**Re: PCD File No. PPR2329  
The Rock Commerce Center, 2nd Review  
Response to Comments**

Please accept this letter on behalf of Central Development, LLC, the applicant for The Rock Commerce Center. We received your comment letter dated December 8, 2023, regarding the application and we offer the following responses:

SHEET  
**EC2.1**

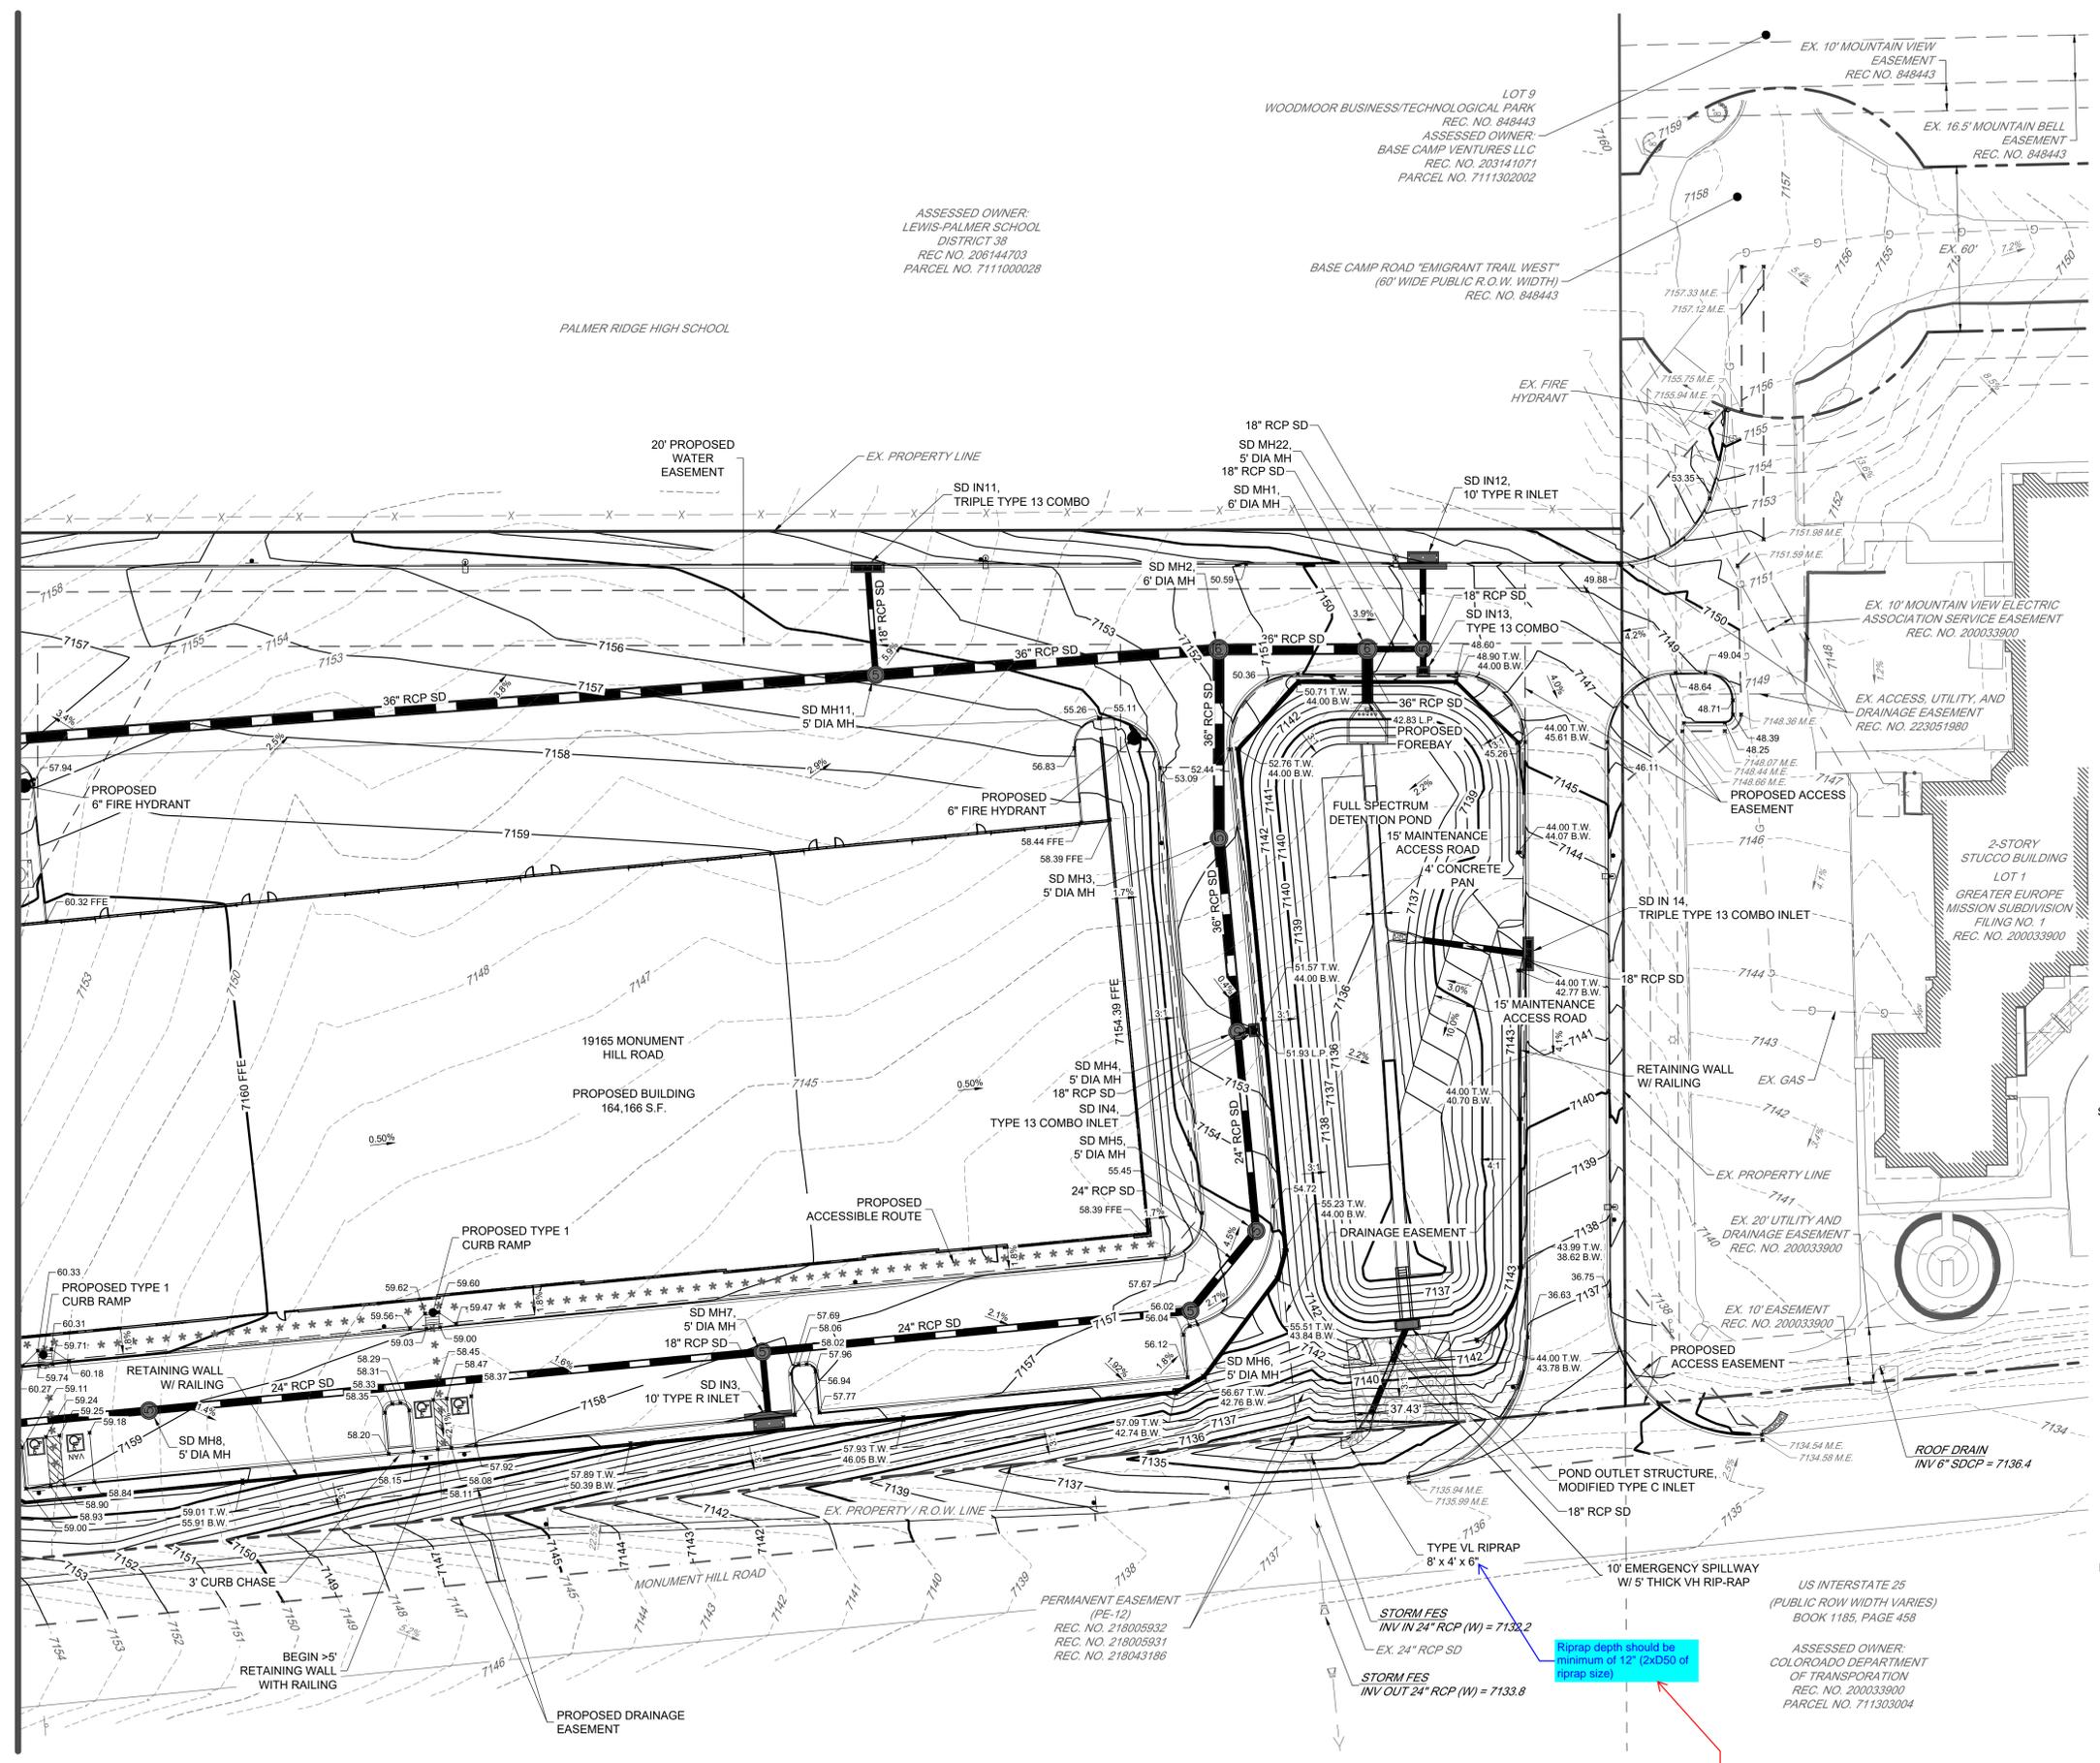
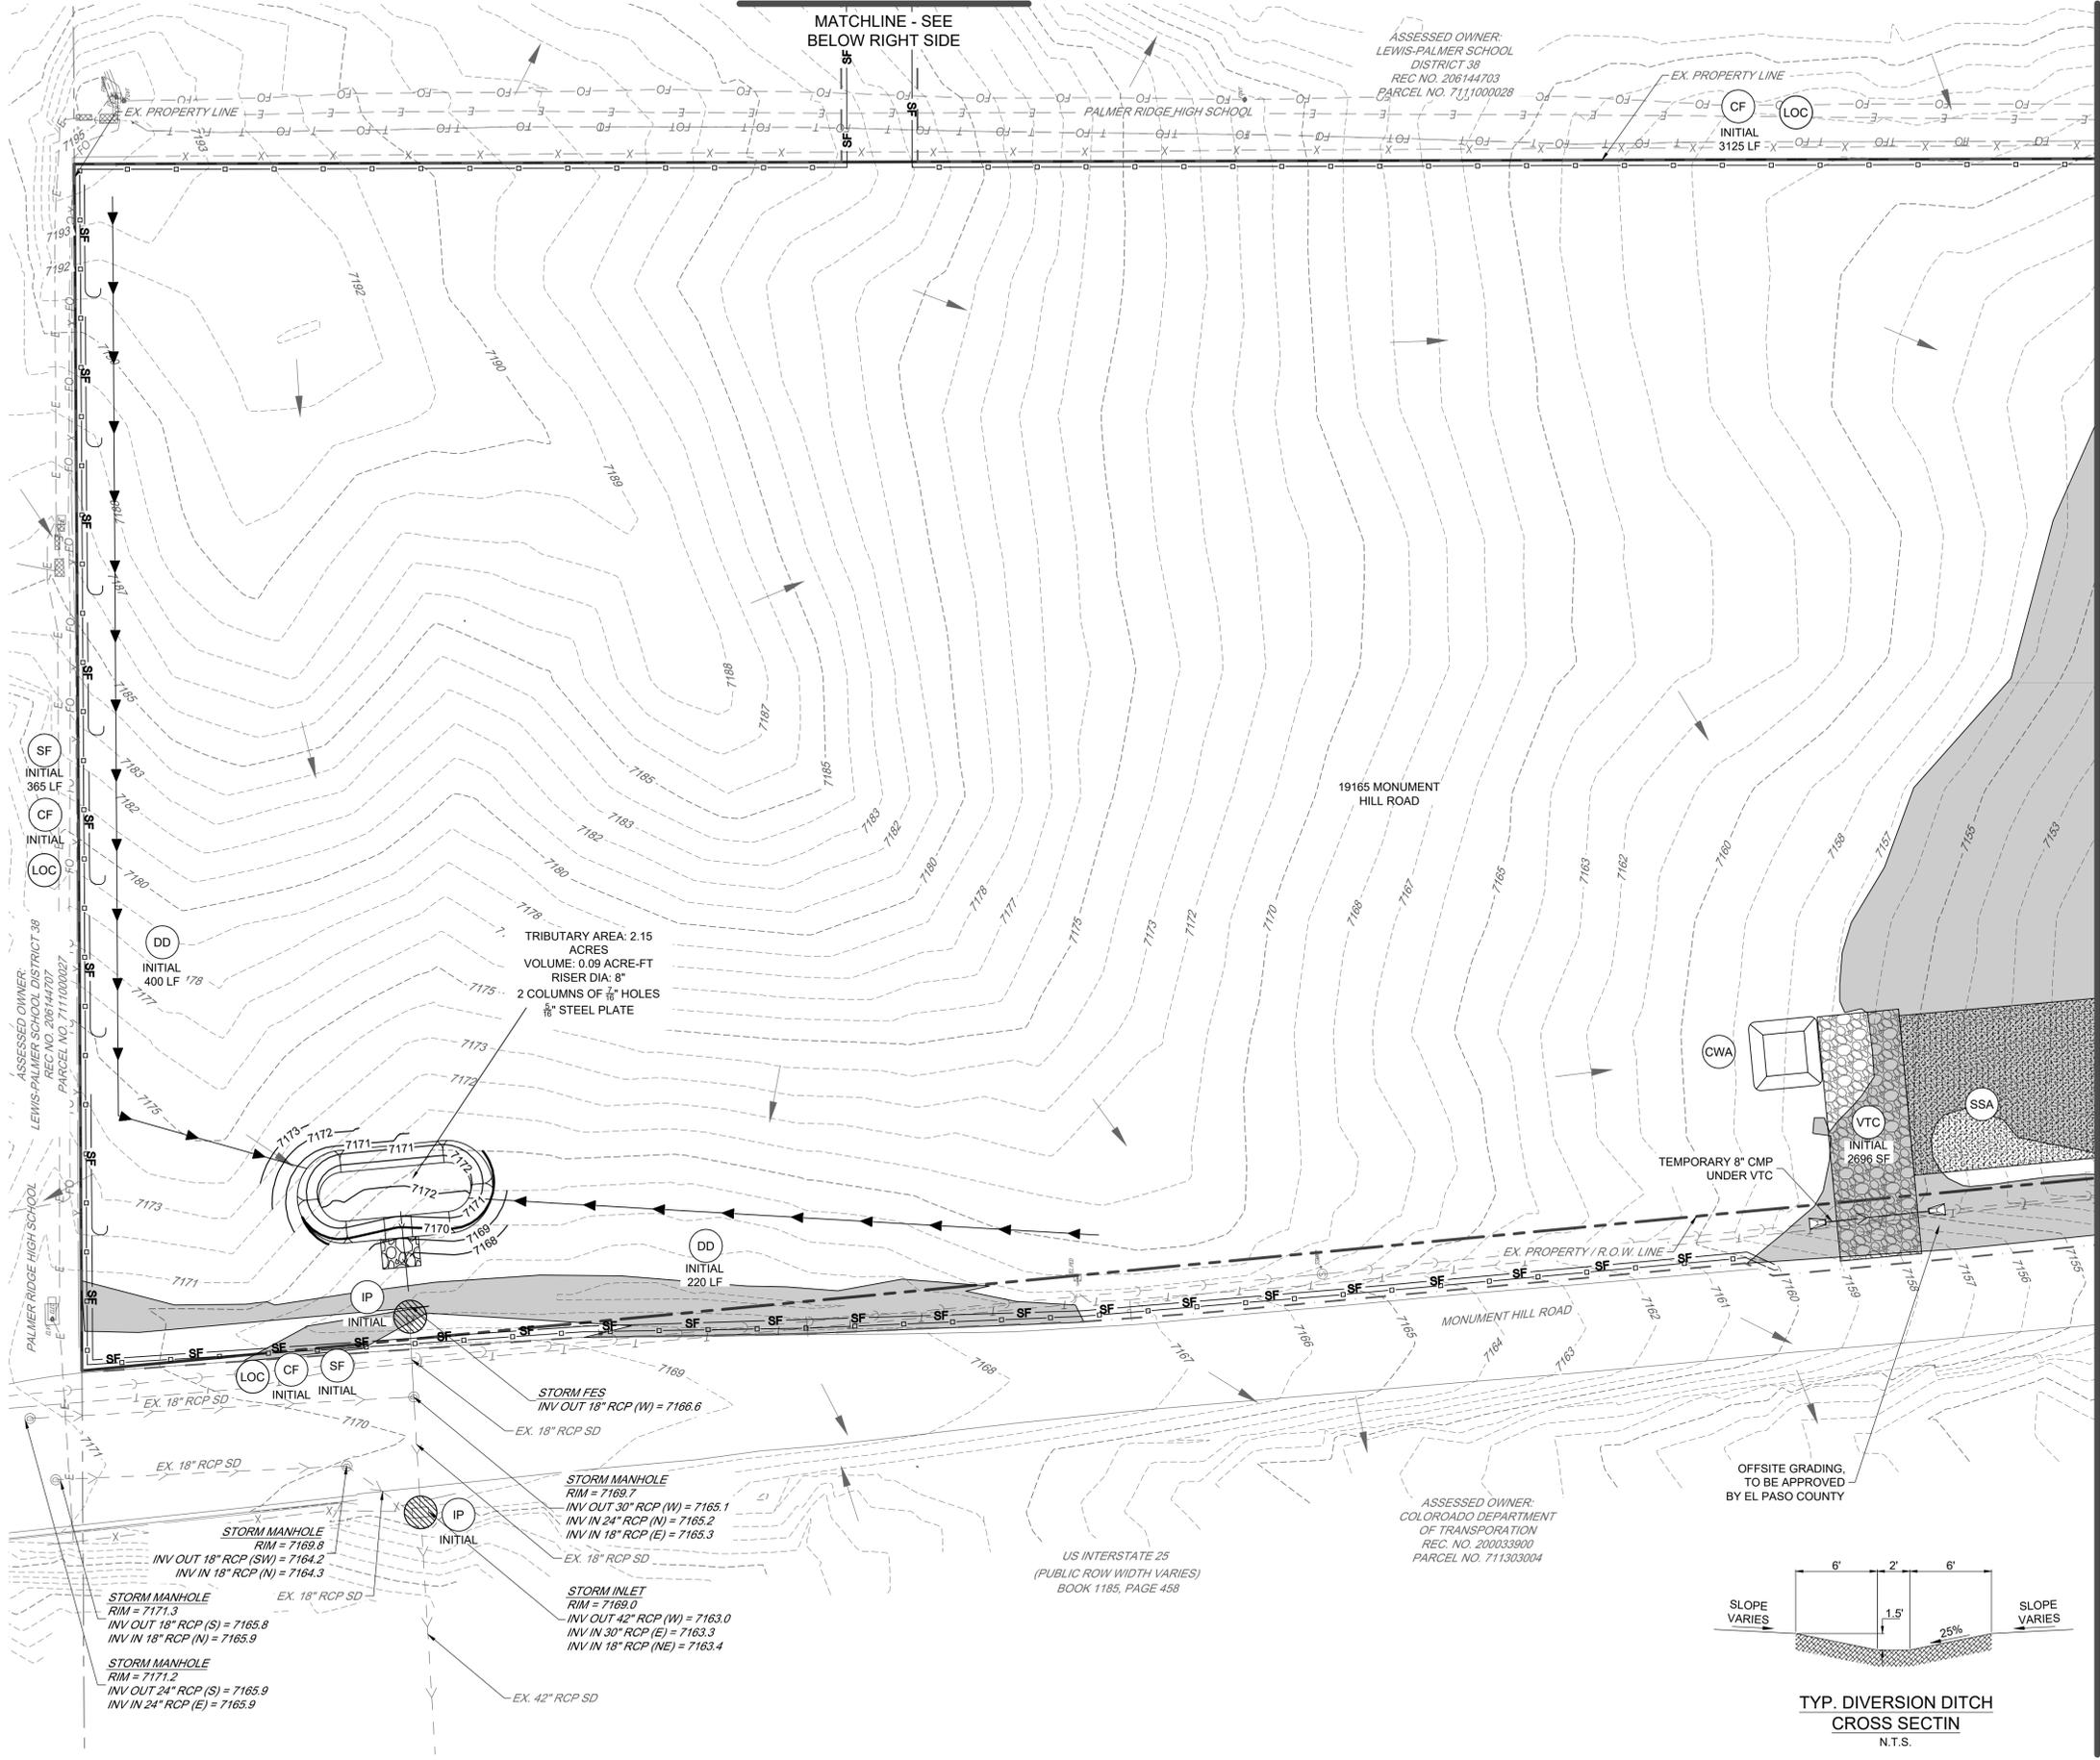
6. Riprap depth should be minimum of 12" (2xD50 of riprap size).

**Response:** The riprap was all updated to be 12" deep on all plans.
